Replacement of MDB4100 with MDB2732

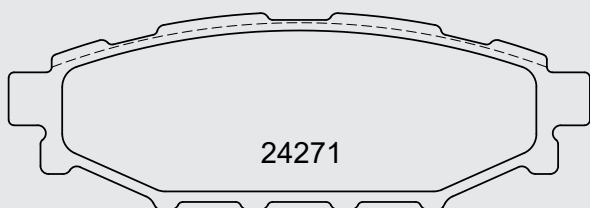
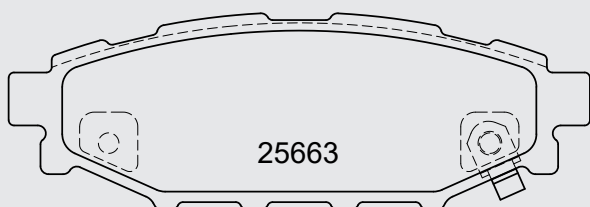
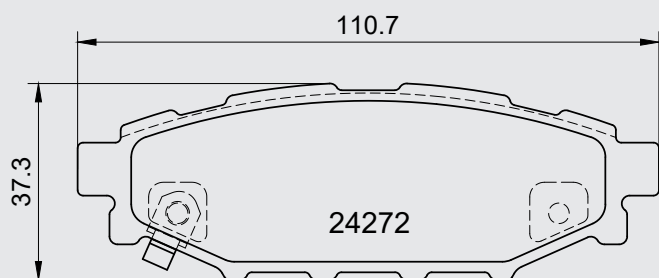
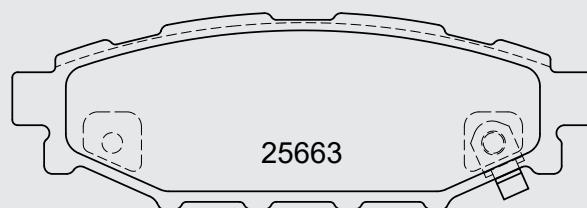
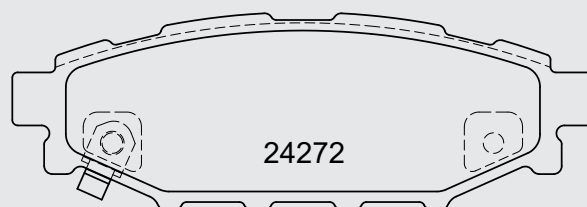
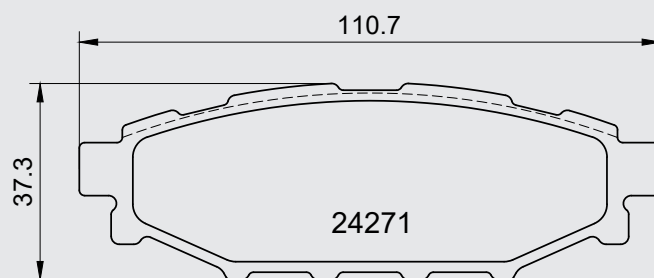
Mintex has decided to change the specification of MDB2732, so that it will also get 2 wear indicators (1x left, 1x right) to ensure the same functionality of MDB4100.

As there are no differences in the outer dimensions there will be no difficulties during assembly and operation. By doing this harmonisation, more vehicles are covered with just one reference (MDB2732), which also provides a logistical benefit for the customer.
